Project	IEEE 802.16 Broadband Wireless Access Working Group < http://ieee802.org/16 >	
Title	Correction to AMC pilot pattern definition	
Date Submitted	2005-04-28	
Source(s)	Yuval Lomnitz Uri Perlmutter Dov Andelman Intel.	Yuval.Lomnitz@intel.com Uri.PerlMutter@intel.com Dov.Andelman@intel.com
Re:	IEEE P802.16-2004/Cor1-D2	
Abstract	Correction to AMC pilot pattern definition	
Purpose	Adopt changes	
Notice	This document has been prepared to assist IEEE 802.16. It is offered as a basis for discussion and is not binding on the contributing individual(s) or organization(s). The material in this document is subject to change in form and content after further study. The contributor(s) reserve(s) the right to add, amend or withdraw material contained herein.	
Release	The contributor grants a free, irrevocable license to the IEEE to incorporate material contained in this contribution, and any modifications thereof, in the creation of an IEEE Standards publication; to copyright in the IEEE's name any IEEE Standards publication even though it may include portions of this contribution; and at the IEEE's sole discretion to permit others to reproduce in whole or in part the resulting IEEE Stand

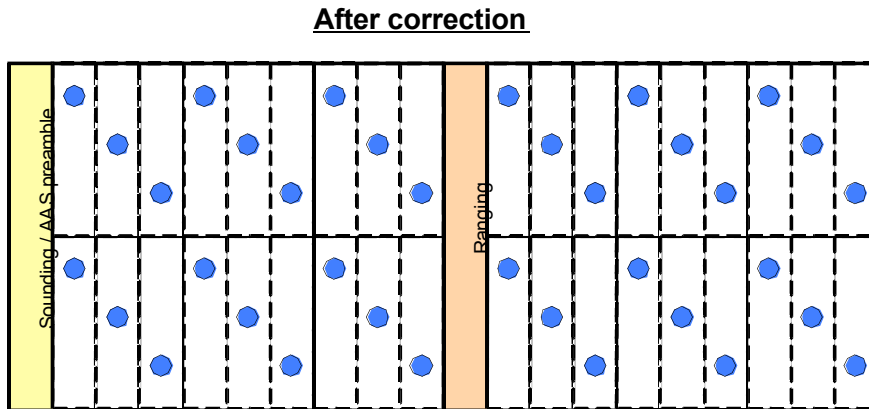
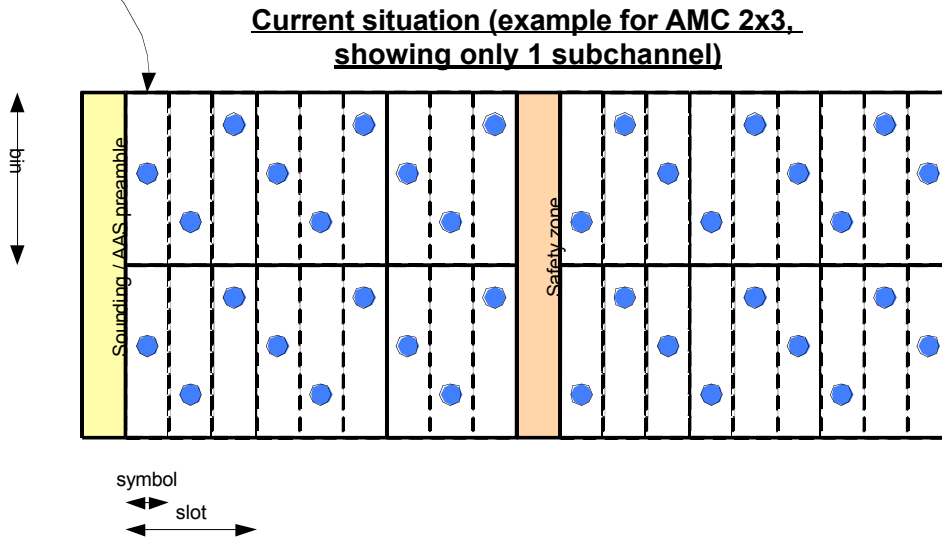
The AMC pilot location is based on symbol index from beginning of zone ($9k+3m+1$). This definition doesn't take into account special symbols (preamble, sounding, etc).

- In the UL, there are symbols in which are entirely filled by rectangular allocations (e.g. Sounding, Ranging (not in AMC), Safety/PAPR reduction zones). In these symbols there are no slots, and the counting of slots resumes after these symbols (see clarifications done in 802.16Cor1/D2, 8.4.4.5). The current AMC pilot structure ignores this fact, so although the actual data contents (slots) is shifted, the pilots remain in same locations, which means that they move relative to the data slots, as shown in diagram below.
- In the DL, MIMO preamble or AAS preambles may cause similar phenomenon, of shifting the pilot pattern (or more accurately shifting the data subcarriers without similar shift of pilots).

Initial phase depends on number of symbols in DL subframe

The simplest way is to define m as symbol offset from start of slot epoch, but in order to be consistent with OFUSC and with all AMC tile structures, we propose to define that m is the symbol offset from the start of the current zone, counting only data symbols (i.e. Safety zones, Sounding symbols, preambles, etc are not counted).
